VENTILATION PLAN CHECK LIST

Mine Name STAR MINE Contact Person JOHN TRUJILLO

RE: Star Mine Operations 05-03528

RE: Star Mine Operations 05-03528; 57.8520 Ventilation plan & 57.11053, Escape and Evacuation plan

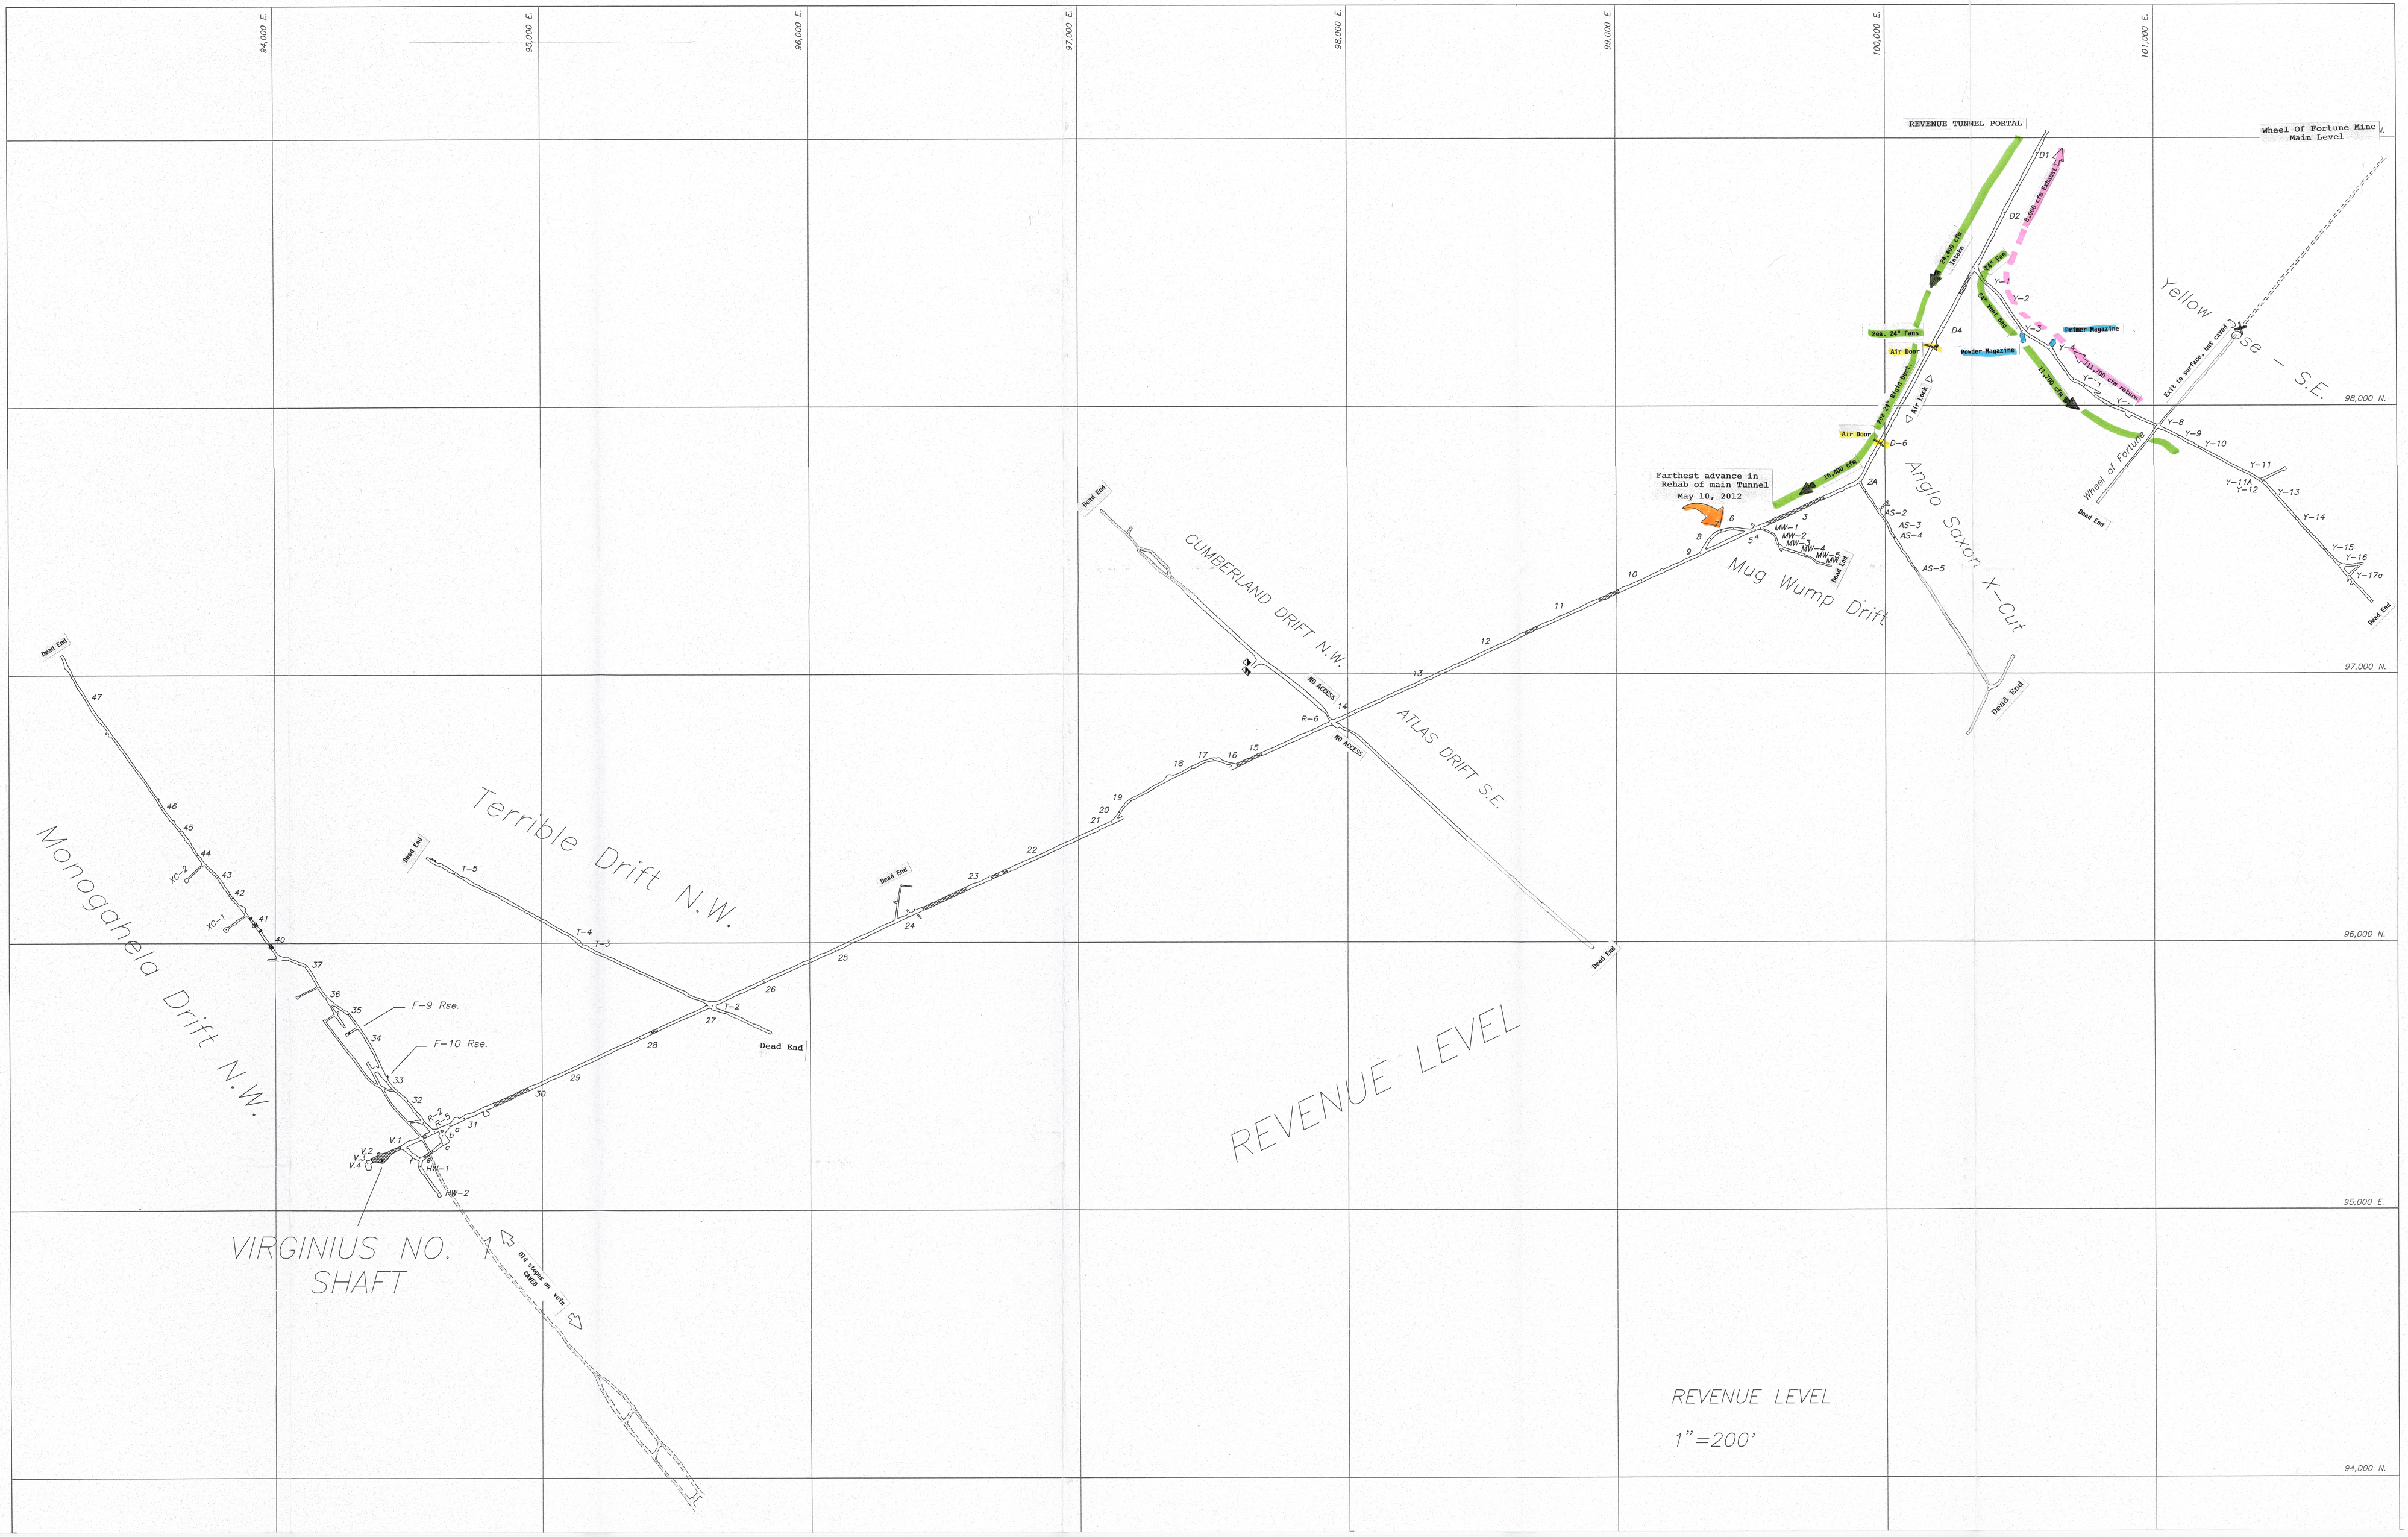
Please provide two copies of larger scale maps showing all underground areas. Please provide detailed locations related to fans and vent bags. Are the fans attached to the bags?

(5) Locations of known underground mine openings adjacent to the mine. (57.8520 (b) (8))

(6) Locations of permanent underground shops, diesel fuel storage depots, oil fuel storage depots, hoist rooms, compressors, battery charging stations and explosive storage facilities. Permanent facilities are those intended to exist for one year or more. (57.8520 (b) (9))

Response: This subject is addressed on the provided mine maps.

Response: During past operations these facilities did exist underground which are inoperative at this time. As we rehabilitate the mine we are evaluating the need for these facilities to be re-established/re-furbished as necessary for future use. The provided mine maps indicate where explosive storage facilities have been established within our current advancement point into the revenue tunnel/mine.

I am providing you with two copies of larger maps, having a scale of 200 ft. to one inch, which shows all known underground areas of the mine that currently contain locations

related to fans which are attached or will be attached to vent bags/tubing to our furthest point of advancement at this time into the Revenue tunnel.
